PROJECT: **ZANJAN UREA FERTILIZER PROJECT**

PROCESS FLOW DIAGRAM

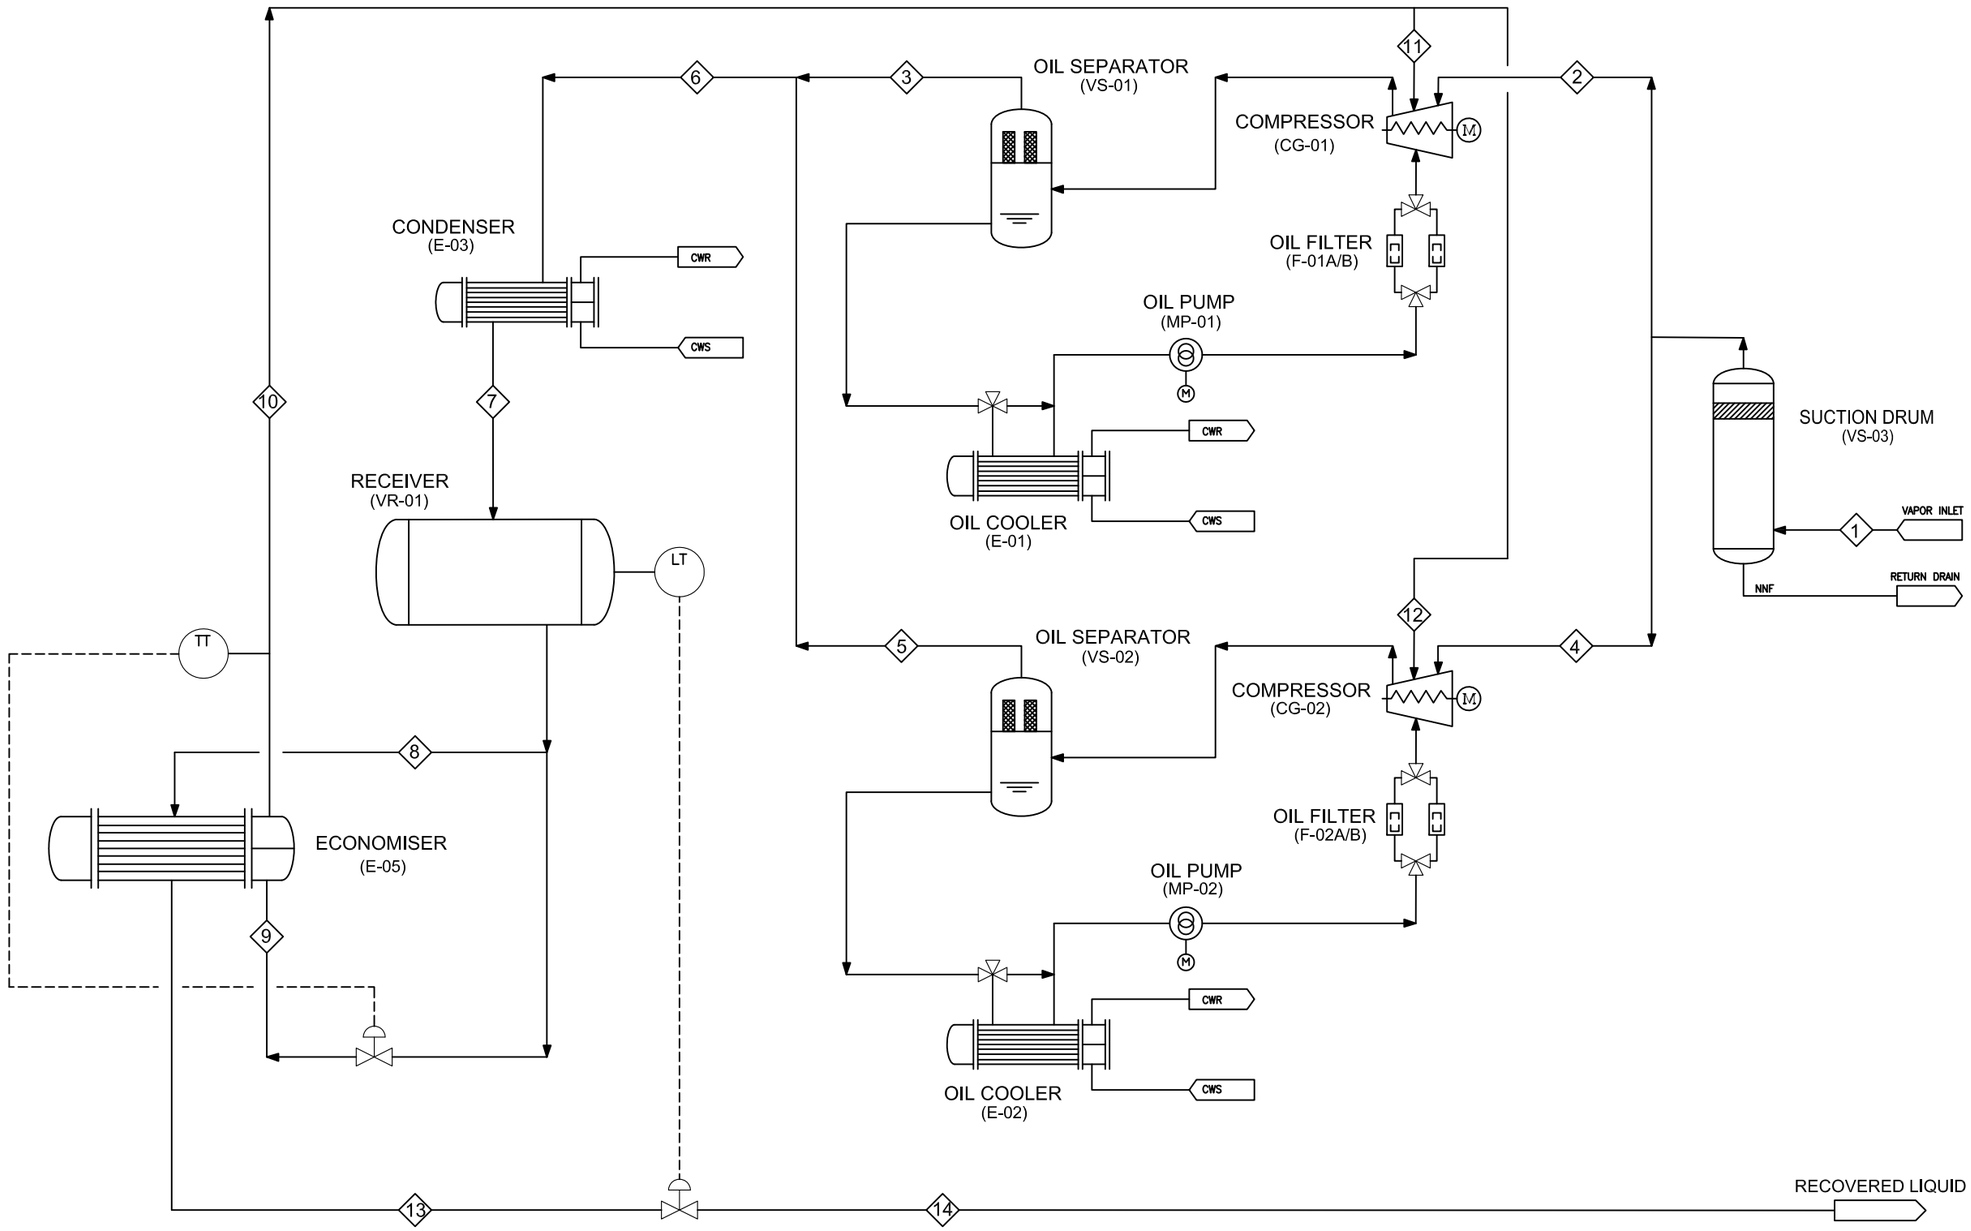
Conclusion meeting:

1) stream lines 9 & 10 shall be checked and calculated again to consider correct temperature and pressure for final revision.
